VIRGINIA ELECTRIC AND POWER COMPANY
RICHMOND, VIRGINIA 23261

Serial No. 03-313K
NLOS/ETS
Docket Nos. 50-338
50-339
License Nos. NPF-4
NPF-7

VIRGINIA ELECTRIC AND POWER COMPANY (DOMINION)
NORTH ANNA POWER STATION UNITS 1 AND 2
PROPOSED TECHNICAL SPECIFICATIONS CHANGES AND EXEMPTION
REQUEST FOR USE OF FRAMATOME ANP ADVANCED MARK-BW FUEL
SUPPLEMENTAL INFORMATION FOR REALISTIC LARGE BREAK LOSS OF
COOLANT ACCIDENT (RLBLOCA) CONTAINMENT PRESSURE ANALYSIS AND
POST ACCIDENT RADIATION HEAT TRANSFER IN THE FUEL ASSEMBLIES

**Supplemental Information for Realistic Large Break Loss of Coolant Accident
(RLBLOCA) Containment Pressure Analysis and Post Accident Radiation Heat
Transfer in the Fuel Assemblies**

Figure 1. Location of Pin Number 11 in the 6x6 Assembly Array.

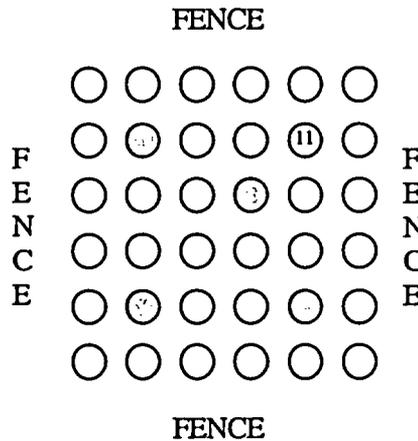
- B. Regarding its proposed license amendment to implement Framatome Advanced Mark-BW Fuel at North Anna Power Station, Units 1 and 2, Virginia Electric and Power Company is requested to confirm that the separation in power between the highest temperature rod and the surrounding rods bounds the power distribution for potential peak temperature rod locations in the core (i.e all rods in the hot bundle within the physics uncertainty on peaking factor) during the entire fuel cycle.

Examining the results from the previous calculation for minimum assembly radiation, the location of minimum rod-to-rod radiation was Pin 11 as shown in Figure 1. Pin 11 was selected as the initial location for use in this calculation, which investigates the influence of rod location on the calculated minimum rod-to-rod radiation.

The calculation results are provided in Table 2. The hot rod radiant heat transfer coefficient is given at Pin 11. Both the assembly average and hot rod results bound the results generated for the FLECHT-SEASET and FLECHT-SKEWED studies. A subsequent PDQ census (i.e., tests at other locations) confirms that performing the analysis at Pin 11 provides the minimum hot rod heat transfer coefficient.
